From: Tim Townsend [REDACTED]
Sent: 03 August 2016 15:27
To: Planning.Responses
Cc: Richard Temple; Tony Sutcliffe
Subject: P/76/16/PL - Proposed packing and preparaiton building - Sefter Farm (Barfoots), Pagham Road, Pagham.
Follow-up Public Rights of Way (PRoW) and Fire and Rescue Service (F&RS) comments

**WEST SUSSEX COUNTY COUNCIL
STRATEGIC PLANNING CONSULTATION**

SUBJECT: P/76/16/PL - Construction of a building for the packaging, preparation & distribution of fresh foods with ancillary accommodation associated with the existing horticultural business, revisions to internal access road, car parking & hardstanding areas & landscaping & provision of a wetland. This application affects the setting of Listed Buildings.

LOCATION: Sefter Farm, Pagham Road, Bognor Regis, West Sussex, PO21 3PX.

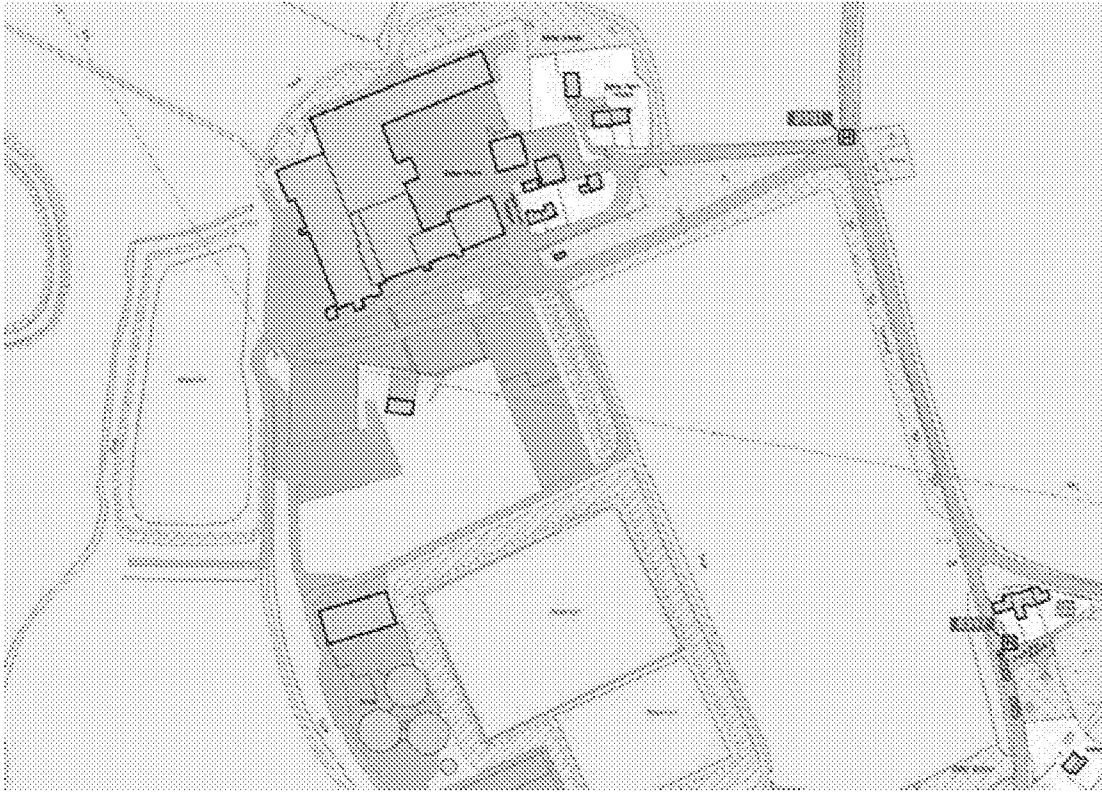
The plans have been reviewed and access to water is sufficient as the building is surrounded by two very large reservoirs and there is a hydrant at the entrance to the site (see plan below). Although this is above the commercial distance specification of 90m, it would suffice whilst pumping from the reservoirs is set up. Access for the fire appliances is acceptable.
